MODIFICATION RECOMMENDED

66311B-08

S E R V I C E N O T E

66311B - MOBILE COMMUNICATION DC SOURCE, 15VDC/3A. GPIB, RS-232

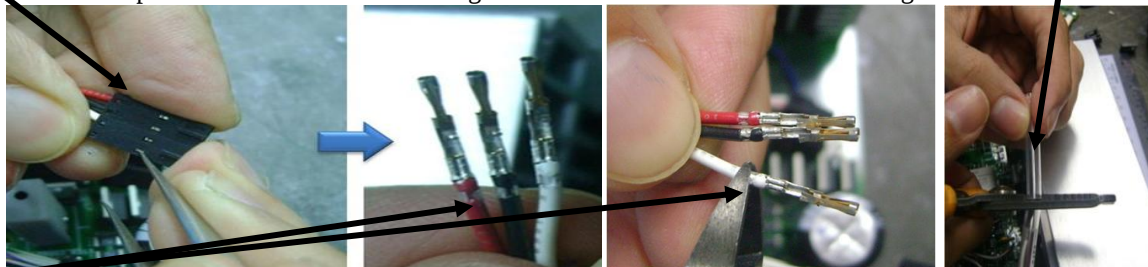
The cable P/N 5080-2452 coming from the control board should be disconnected for the mail connector (circuit reference) "J206" which is soldered on the interface board.

Remove the connector P/N 1252-3695 (circuit reference) "J206" on the "A2" interface assembly. When removing "J206" care should be taken not to damage the "A2" printed circuit board material or the circuit board traces. "J206" has 4 holes remove the solder from these holes as shown. Do not apply too much heat or pressure this may cause damage to the PCA

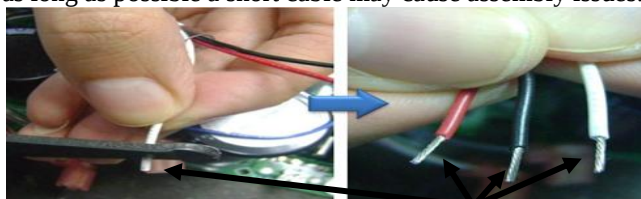
Remove the pins from the connector housing as shown. Cut 3cm off the clear tubing of the cable

Cut the crimped terminals at the crimp around the wires colored insulation. This is done so the cable length can be as long as possible a short cable may cause assembly issues.

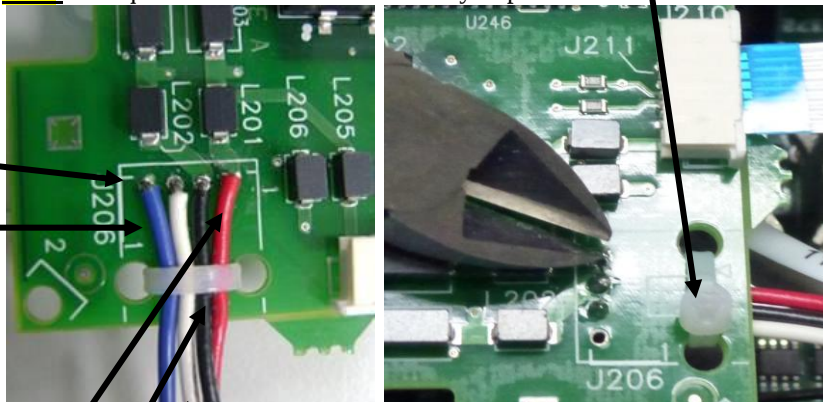
Insert the cable into the open holes located on the “A2” GPIB interface assembly.

Depending on the model there may be three or four wires.

The **Red** wire is soldered in the main control board (reference E320) and should be soldered into pin #1 or the square pad of “J206” on the “A2” interface assembly.

The **Black** wire is soldered in the main control board (reference E324) wire should be soldered into pin #2 of “J206” on the “A2” interface assembly. .

The **White** wire is soldered in the main control board (reference E321) should be soldered into pin #3 of “J206” on the “A2” interface assembly.

The **Blue** wire is required for the models shown below **ONLY**. This **Blue** wire comes from the connector on the battery emulation board P/N 5064-0131 circuit reference J001 Pin 12, the **Blue** should be soldered into pin # 4 of “J206” for the models listed below only. All other **66300X Mobile Comm DC Sources** only require 3 wires.
